USB 3.0 ENGINEERING CHANGE NOTICE

ECN #012

Title: USB3.0 Reference Equalizer

Applied to: USB3_r1.0_06_06_2011

(a). From Text (and location): Section 6.8.2, Page 6-25, Figure 6-17

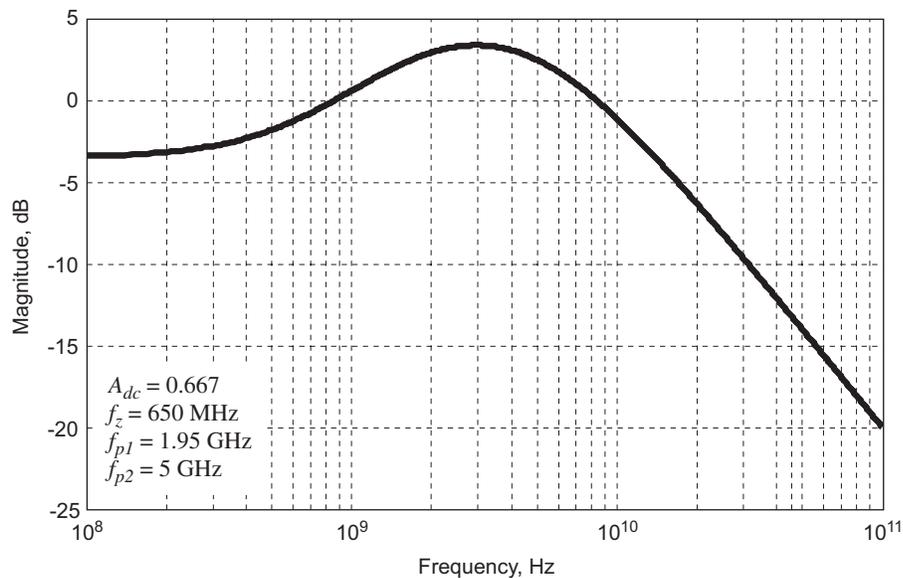
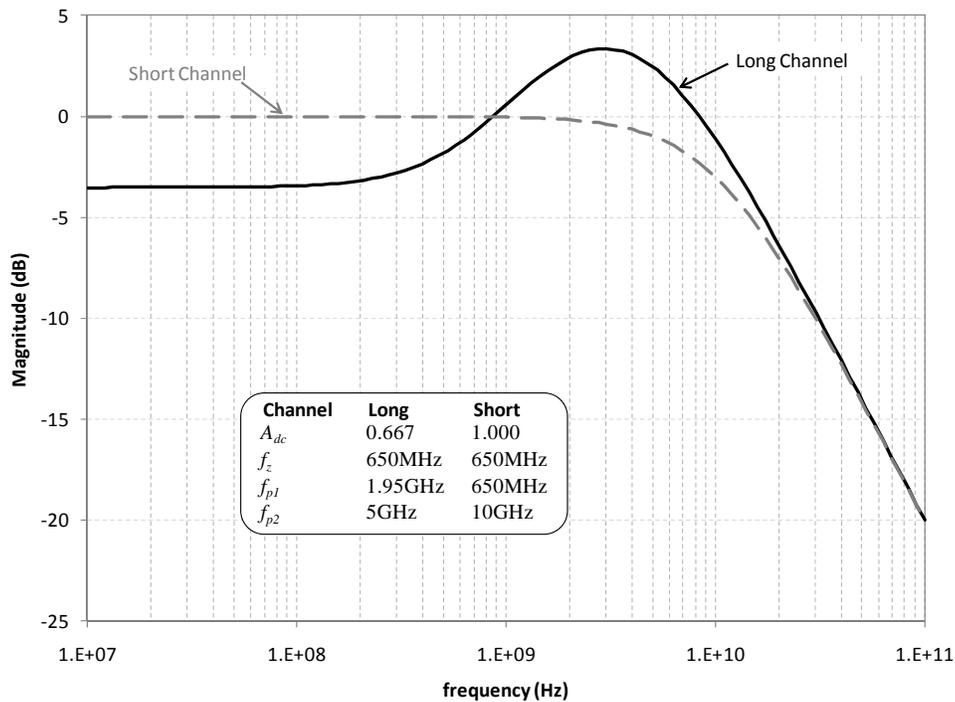
Section 6.8.2 contains a reference transfer function for the receive-side equalizer (informative spec). This reference equalizer function is tailored to a long channel (3m cable plus long host PCB trace, ~18-20dB differential insertion loss). Due to concerns raised about ensuring proper equalizer behavior in a short channel (no cable and short host PCB, ~3-5dB differential insertion loss), it is proposed to add a second informative reference equalizer transfer function that is optimized for the short channel.

The equation for the continuous time linear equalizer (CTLE) used to develop the specification is the compliance Rx EQ transfer function described below.

Error! Reference source not found. is a plot of the Compliance EQ transfer function.

where A_{dc} is the DC gain
 $\omega_z = 2\pi f_z$ is the zero frequency
 $\omega_{p1} = 2\pi f_{p1}$ is the first pole frequency
 $\omega_{p2} = 2\pi f_{p2}$ is the second pole frequency

Error! Reference source not found. is a plot of the Compliance EQ transfer functions with the values for each of the input parameters.
